Re: Discharge of Condition 19 of LB Camden planning permission 2016/5375/P

Arboricultural Letter of Support: 16 Avenue Road, London NW8 6BP Instructing party: Jackson Coles LLP, Morelands, 5-23 Old Street, London, EC1V 9HL Prepared by: Adam Hollis of Landmark Trees, Holden House, 4th Floor, 57 Rathbone Place, London W1T 4JU

GROUND FLOOR PLAN DRAINAGE

AA MO'R COTOBER 2019 YOUR For Pricing BONUE 1 : 100 ⊕ Δ1 11940/DR/GF/S-223 P3

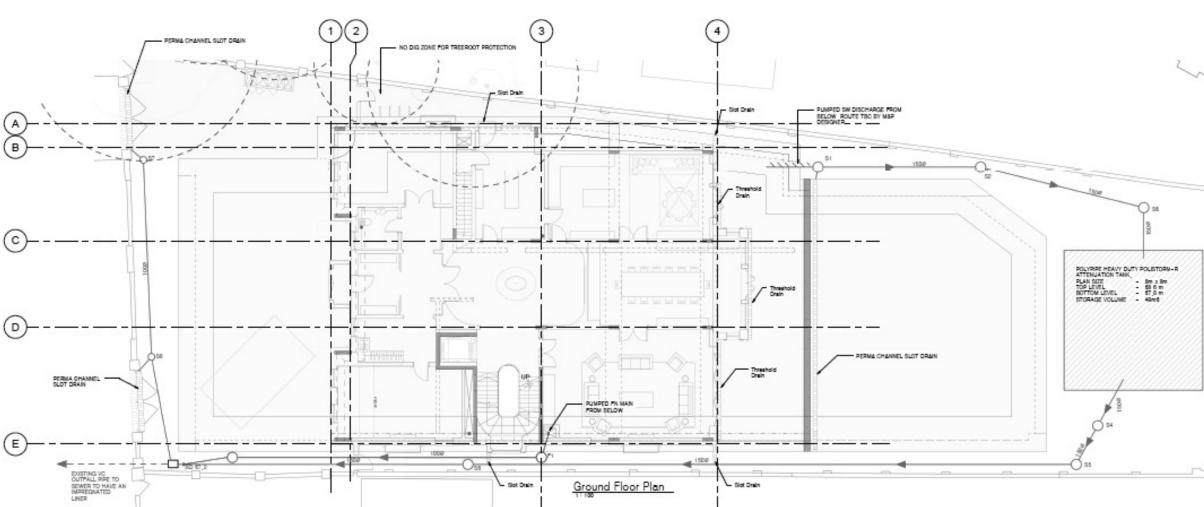
Drawing 11940 S-223 confirms that the proposed below ground drainage has been designed to avoid tree

root protection areas and therefore specialist methods are not required.
